DELEGATED APPLICATION REPORT

App Ref: PL/25/0491

Address: 47 Parkside Road, Reading, RG30 2BT

Proposal: Erection of 1no. five-bedroom detached dwelling comprising two storeys, together with on-site car parking, secure cycle parking and refuse storage, together with landscaping. Vehicular and pedestrian access via Wingrove Road, following the demolition of all structures on the Site.

- (Proposed Site Layout Plan- Land to the rear of No.47 Parkside Road)

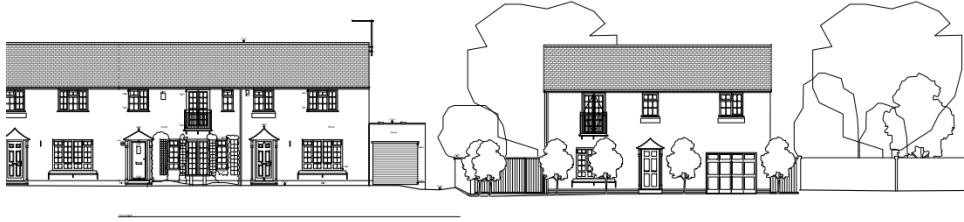
The proposed Dwelling would front Wingrove Road, which is characterised by rows of terraced properties with an open feel. The proposal dwelling is at odds with the existing pattern of development within the vicinity of Wingrove Road which consist of terraces to the west of the site (and properties to the south) and would sit within the characteristically large garden of no.47 Parkside Road.

Furthermore, there would appear to be insufficient space for meaningful amenity areas and soft landscaping which results in a cramped overdevelopment of the site, harmful to the appearance of the area and its spacious character. Furthermore, the siting, of the development fails to respect the existing building lines of adjacent properties and as such appears at odds failing to harmonise with the character of the area.

The proposal would be a significant change to the character and appearance of the area and be detrimental to the overall spaciousness and openness presented between the distinctly different areas in which the site is related to. Therefore, the proposal is considered to be overdevelopment in scale and form of the proposed site and would therefore be considered to be in conflict with Policy CC7 of the Reading Local Plan (2019).

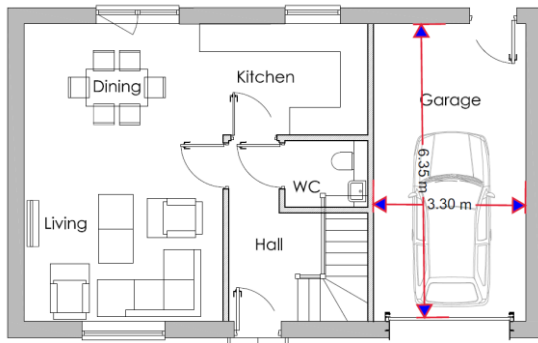
The site is within Zone 2, the primary core area but on the periphery of the central core area which lies at the heart of Reading Borough, consisting primarily of retail and commercial office developments with good transport hubs. The application the construction of 1 x 5 bedroom dwelling in the rear garden area of No47, proposed dwellings will be accessed from newly created vehicle crossing from Wingrove Road.

In accordance with the Councils current Parking Standards and Design SPD the new dwelling would require 2 off street parking spaces. Submitted floor plans illustrate a garage is to be provided, the recommended internal dimensions for a single garage as stated in the Councils current Parking Standards and Design SPD are 7m x 3m. While the width meets requirements the length falls short. The garage door opening into the garage further restricts the available space.

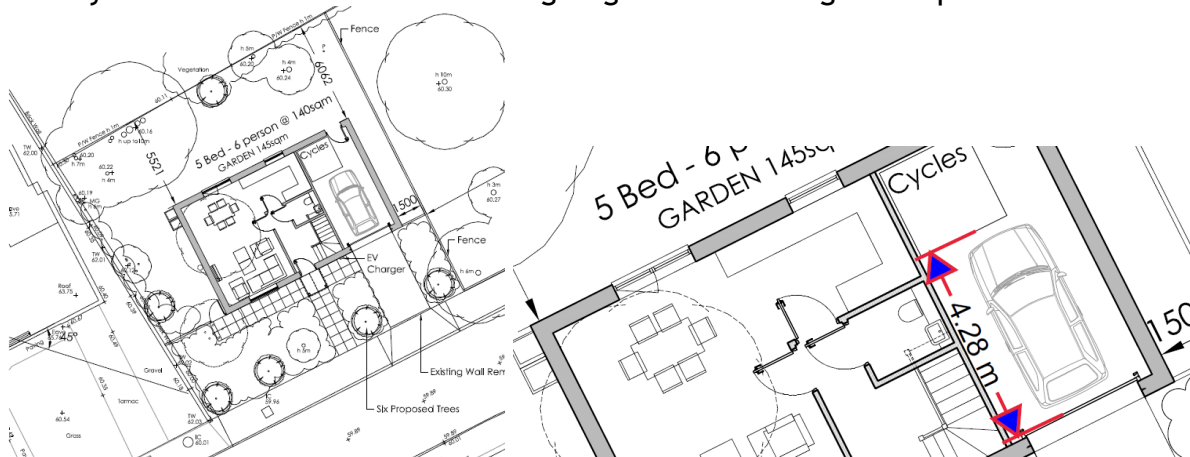
The site plan (extract below) illustrates cycle storage within the proposed garage which would further reduce the existing space, the reduced length of the garage can only be considered if cycle storage is moved into a secure garden shed located in the private amenity area and the direction of the garage door is changed to open outwards.

A second parking space is provided in front of the garage the introduction of a vehicle crossing will require a license from the Highways team. **Plans are required illustrating the proposed vehicle access point, visibility splays of 2.4m x 43m.** The applicant has made reference to visitor parking, as previously advised this is not a requirement for this development and should not be a substitute for the 2 parking spaces required for the development.
